Re: Robert Marc Fisher ZBA application
7 Berachah Ave.
South Nyack, NY 10960

UPDATED NARRATIVE

Review of Plans: Fisher Site Plan, 7 Berachah Avenue, South Nyack, NY
Section 66.61 Block 1 Lot 19-2 R-12HC zone

Subject: **Fisher Site Plan**
7 Berachah Avenue, South Nyack
Section 66.61, Block 1, Lot 19.2, R-12HC zoning district

PLANIMETRIC PLAN (SHEET 1 OF 5)
FOR
FISHER

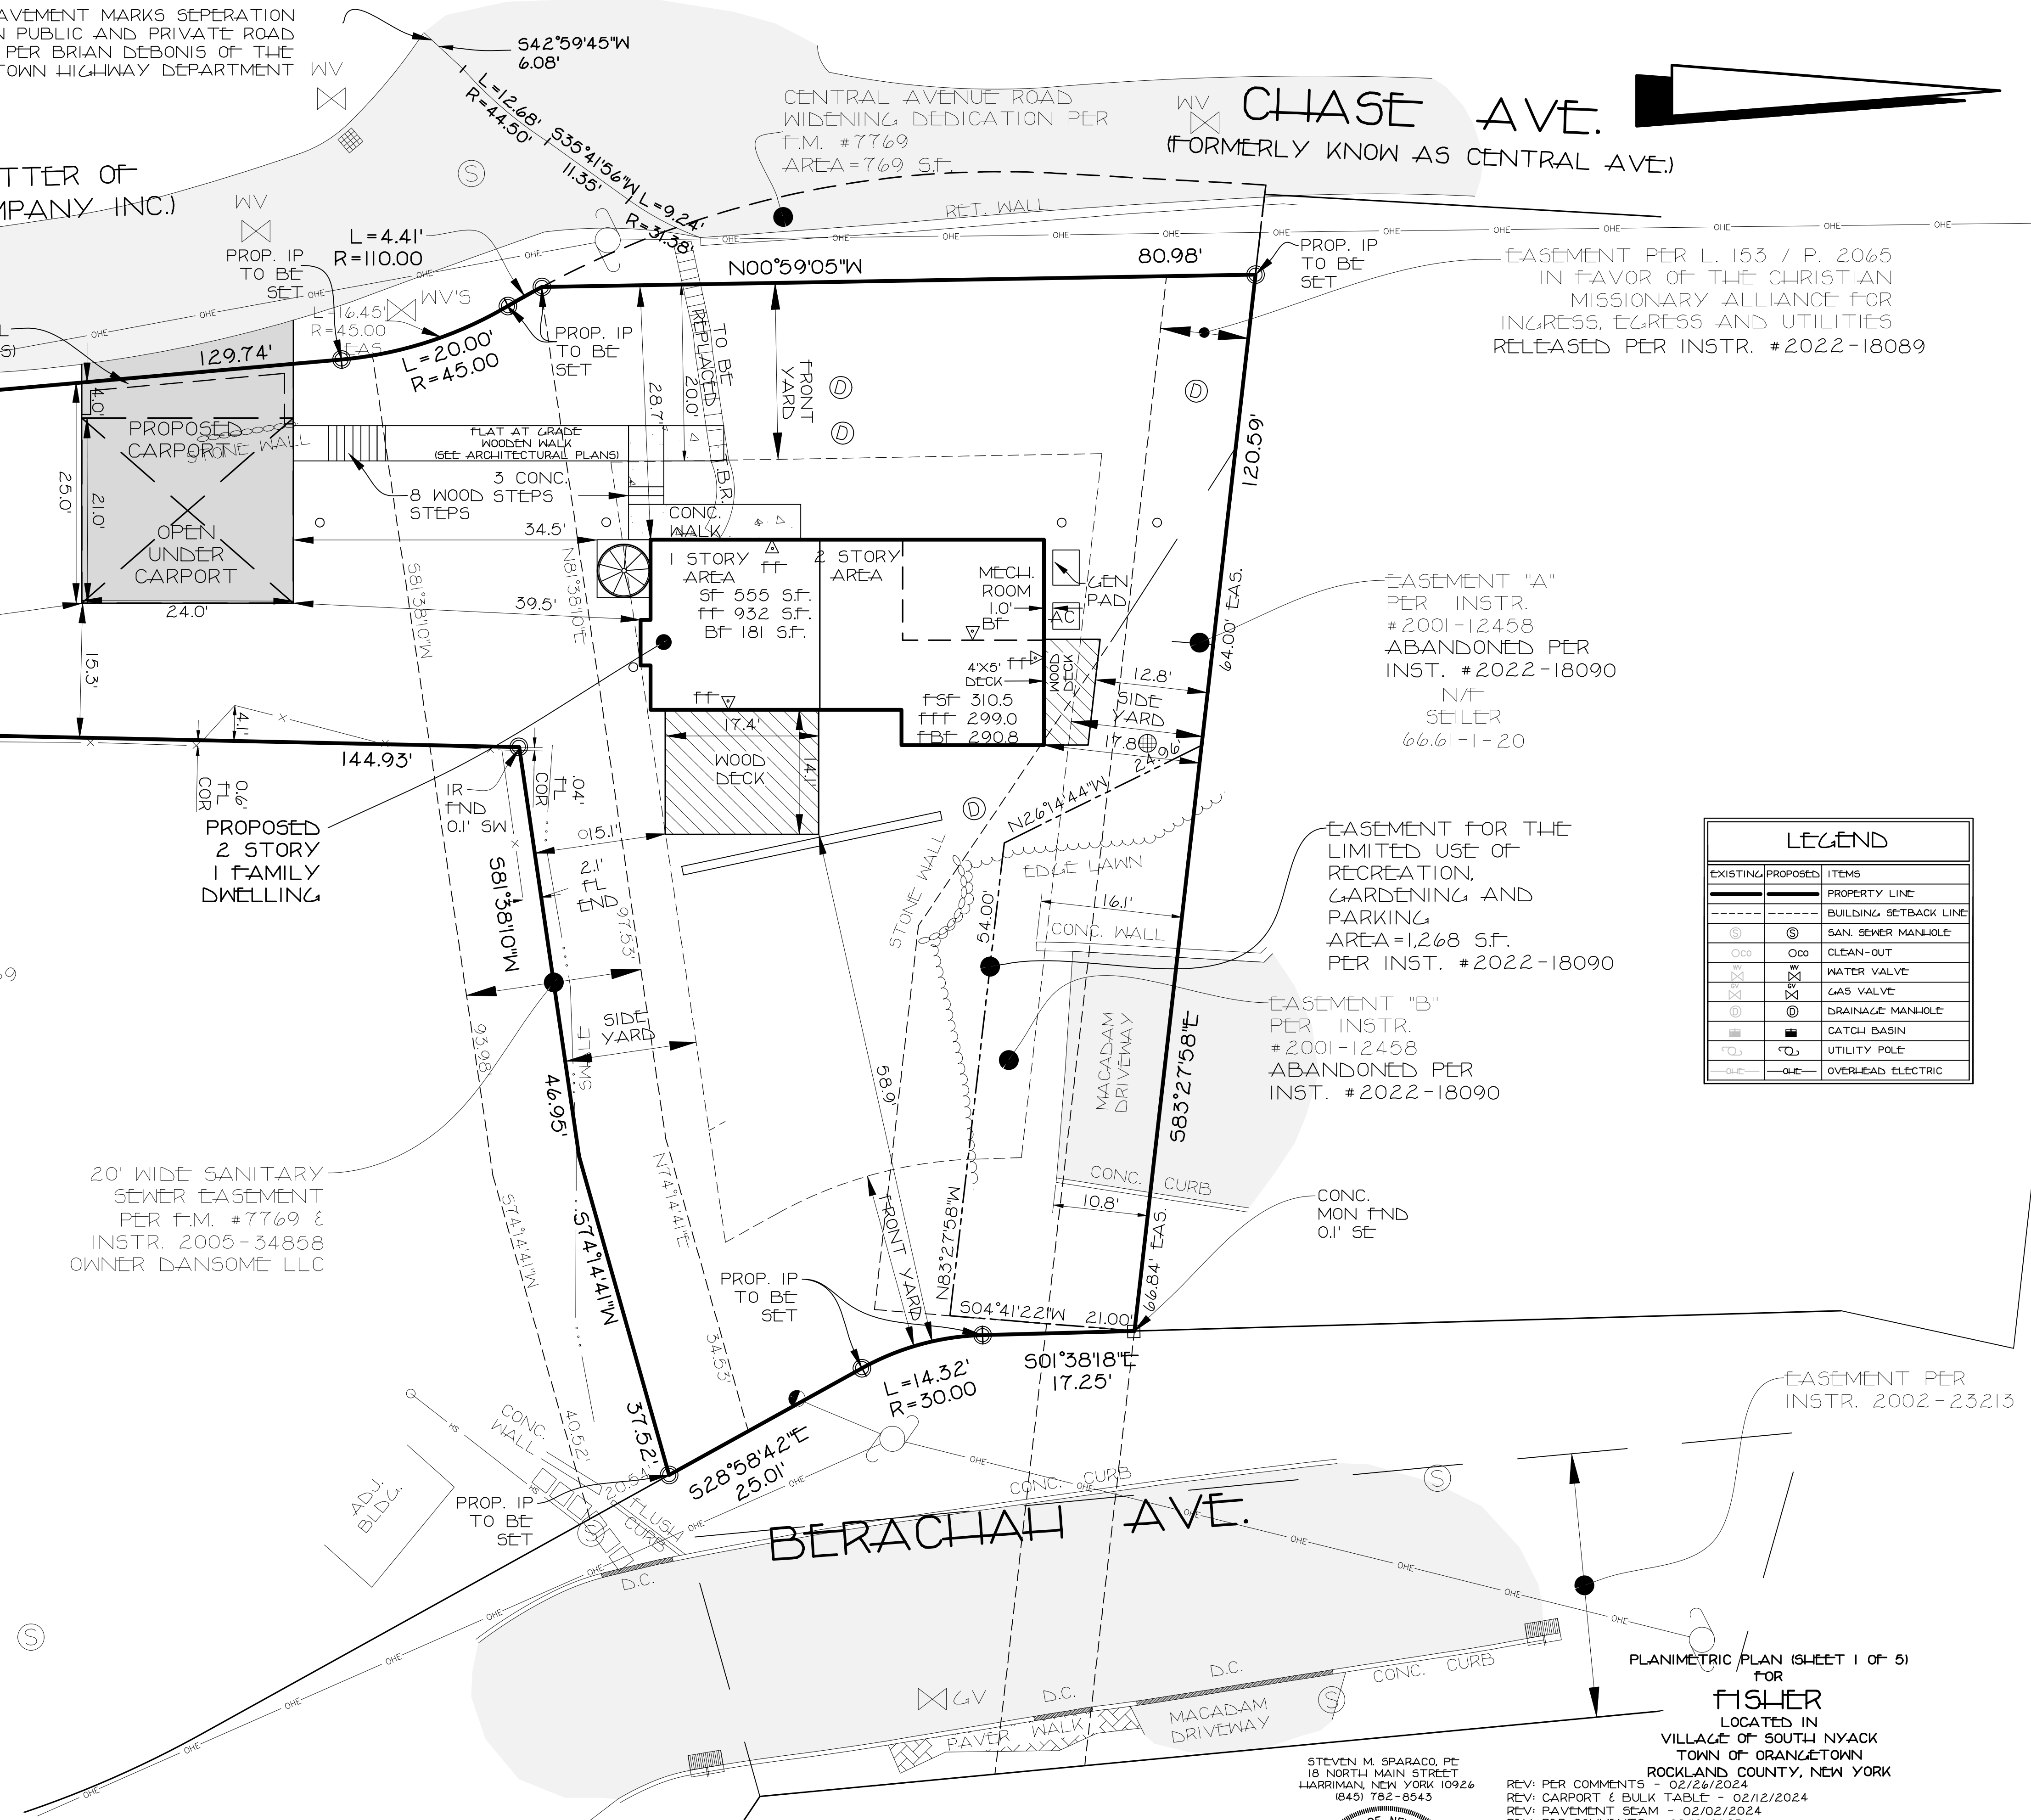
- Sheet 1 of the site plan by Sparaco & Youngblood PLLC depict the slopes of the property as patterns, which are overlain with different features, making the plan difficult to read. A separate sheet must be used to illustrate the slopes.

GRADING, UTILITIES AND EROSION CONTROL PLAN (SHEET 2 OF 5) FOR FISHER LOCATED IN VILLAGE OF SOUTH NYACK TOWN OF ORANGETOWN ROCKLAND COUNTY, NEW YORK

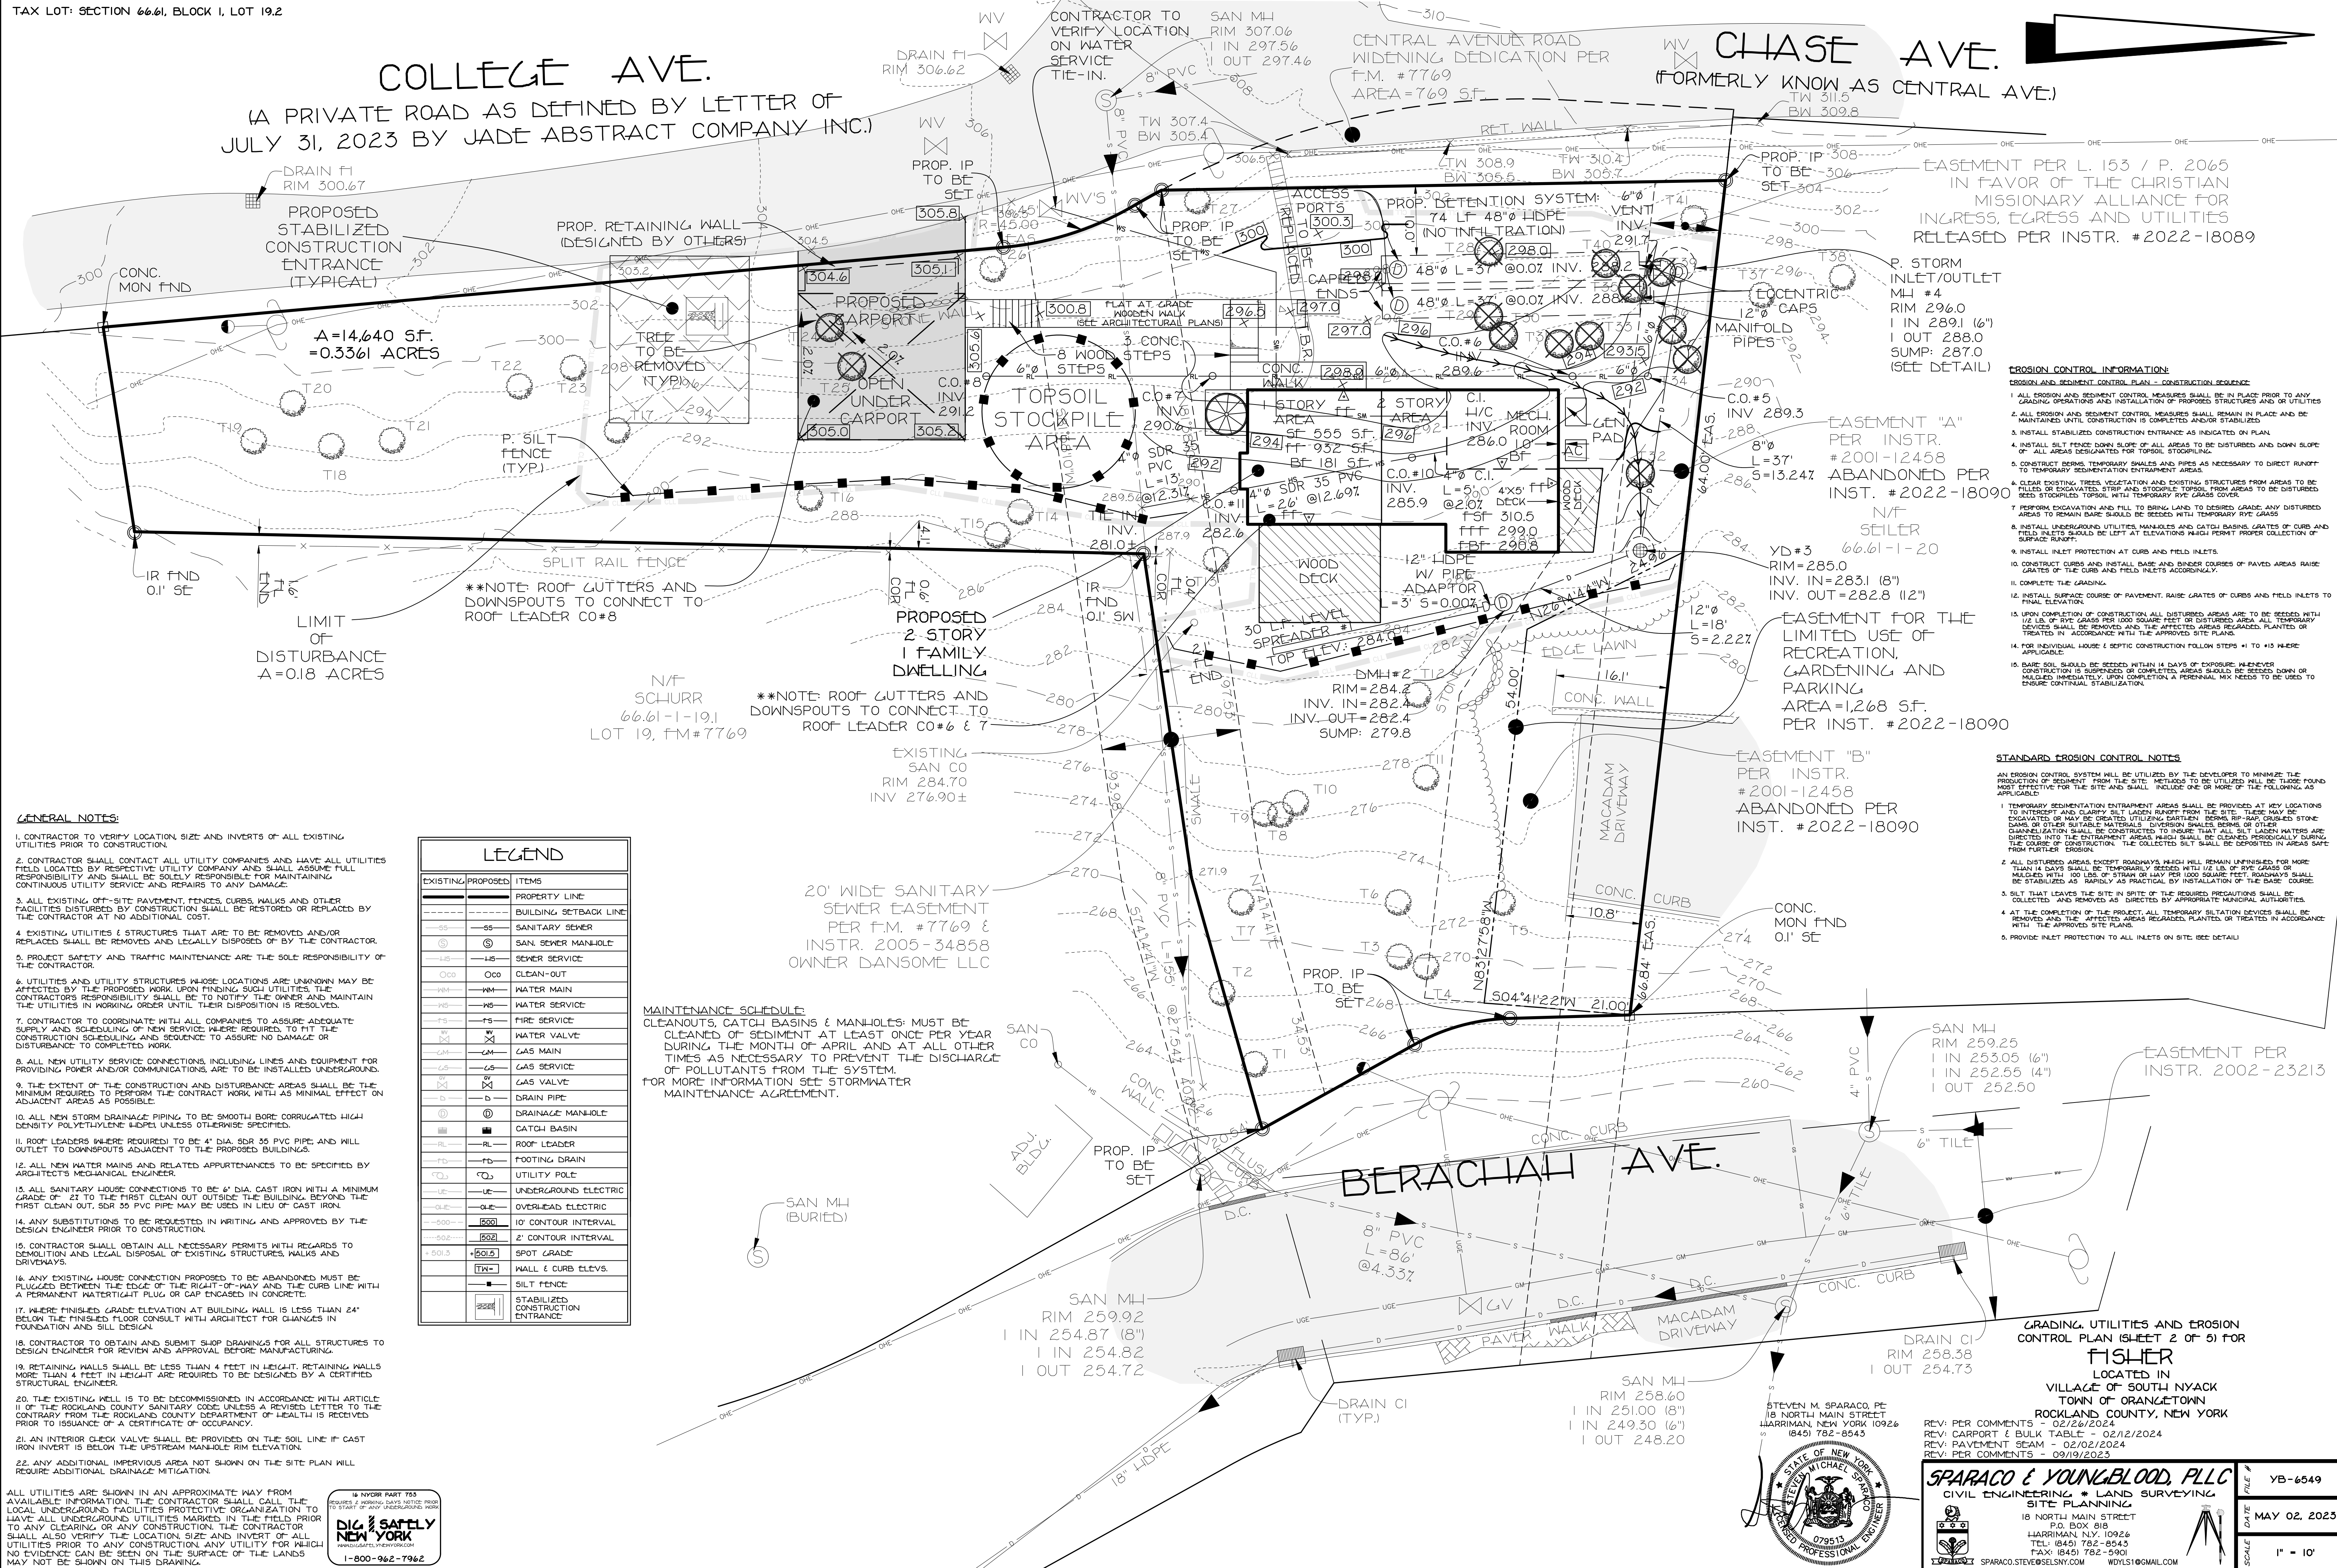
19. Sheets 2 & 3 label the "P Storm inlet/ outlet" manhole as #4. However, the detail for same on sheet 5 labels it as manhole #2. The labels shall be coordinated.

20. A note shall be added to sheets 2 & 3 saying "The Town of Orangetown Sewer Inspector shall be notified at least 48 hours in advance of **ANY** work being done on or near the existing sanitary sewer main and or the proposed sanitary building connection."

DETENTION SYSTEM SECTION DETAIL

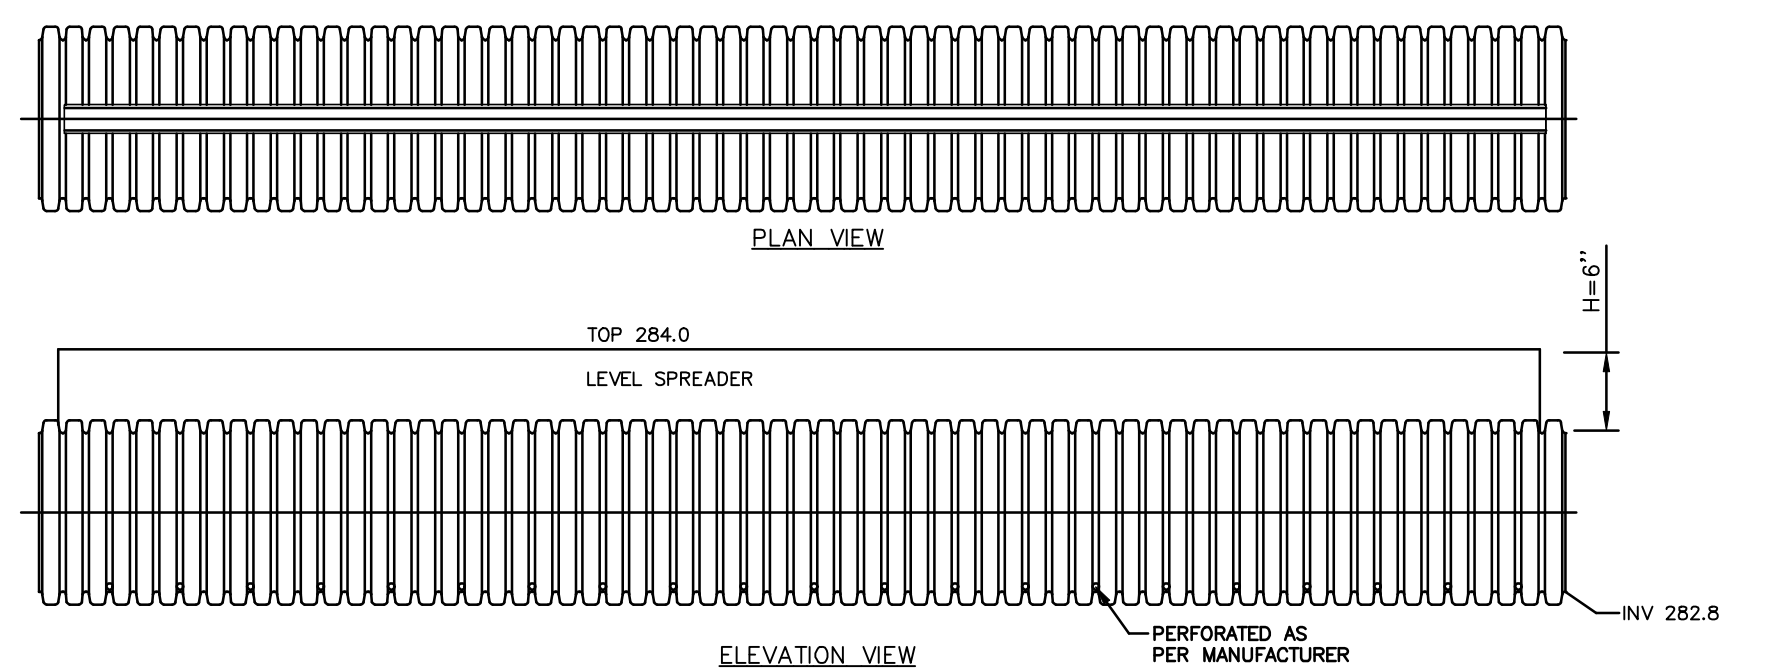
16. A detailed plan and elevation view shall be provided for the proposed dual 48-inch stormwater detention system, which shows: interconnection via manifold, top & invert elevations, etc. Only a cross-section is provided.
